Johns Creek

Board of Zoning Appeals Meeting
September 21, 2021

CASE NUMBER:	V-21-007
PROPERTY LOCATION:	9095 Barkston Drive, Johns Creek, GA 30022
CURRENT ZONING:	CUP (Community Unit Plan District) Conditional
PARCEL SIZE:	0.73 Acres
PROPERTY OWNER:	Andy Wren
VARIANCE REQUEST:	Encroach into the 50-foot undisturbed buffer and 75-foot impervious surface setback to construct a new house and a pool
STAFF RECOMMENDATION:	APPROVAL WITH CONDITIONS

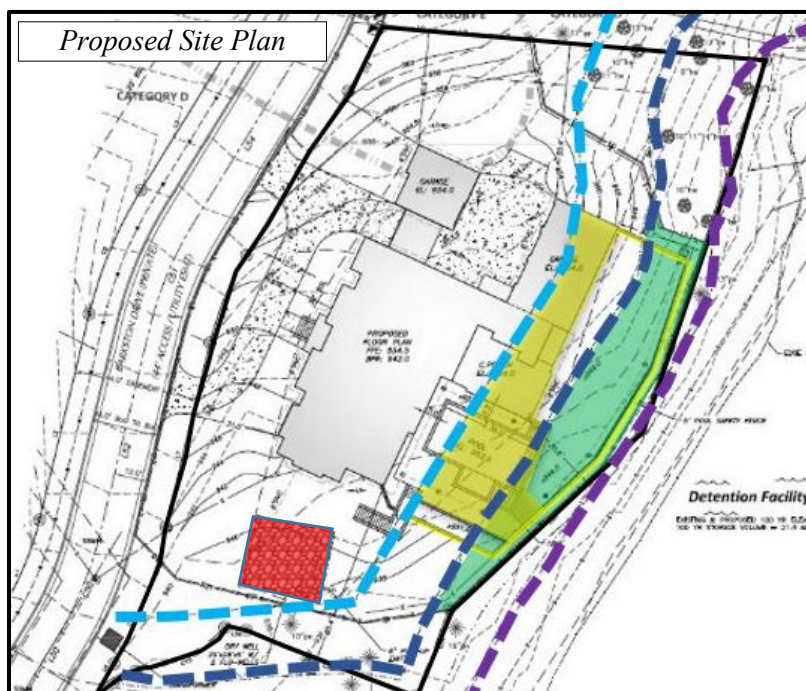
The Applicant is requesting a stream buffer variance to disturb 3,220 square feet (shown in green) in the 50-foot undisturbed buffer, and adding 2,738 square feet of impervious surface (in yellow) in the portion of the additional 25-foot impervious surface setback, to construct a new house and a pool. The Applicant has not proposed any land disturbance or impervious surface within the State's 25-foot stream buffer.

In order to offset the adverse impacts associated with the encroachment, the Applicant has proposed to install a dry well (in red) that would hold an additional 238.5 cubic feet of stormwater runoff.

The subject property was platted in 2019 without showing any stream buffers. However, a recent site visit confirmed the presence of wretched vegetation around the lake, requiring the 75-foot stream buffer to be applied to the rear of the property. The addition of the stream buffer would create a hardship for the homeowner, requiring them to apply for a variance. In order to mitigate the impact of encroachment into the stream buffer, the Applicant has proposed installing a dry well to capture an additional 238.5 cubic feet of stormwater runoff.

- 1) The proposed development shall not exceed the following encroachments, as shown on the site plan received by the Community Development Department on August 25, 2021:

- a. 3,220 square feet of disturbance within the 50-foot undisturbed stream buffer;
 - b. 2,738 square feet of impervious surface into the 75-foot impervious surface setback.

- 2) No land disturbance shall occur within the State 25-foot stream buffer.
- 3) A stream buffer mitigation plan shall be submitted to the Community Development Department, and approved by the City's Land Development Manager, prior to the issuance of a building permit. Said plan shall be consistent with the mitigation plan proposal received by the Community Development Department on August 27, 2021. The mitigation plan shall pass City inspection prior to the issuance of a Certificate of Occupancy.

- 4) Owner/Developer shall revise and re-record the final plat to reflect the 25-foot State undisturbed buffer, 50-foot City undisturbed stream buffer and additional 25-foot impervious surface setback on the property, prior to the issuance of a Certificate of Occupancy.
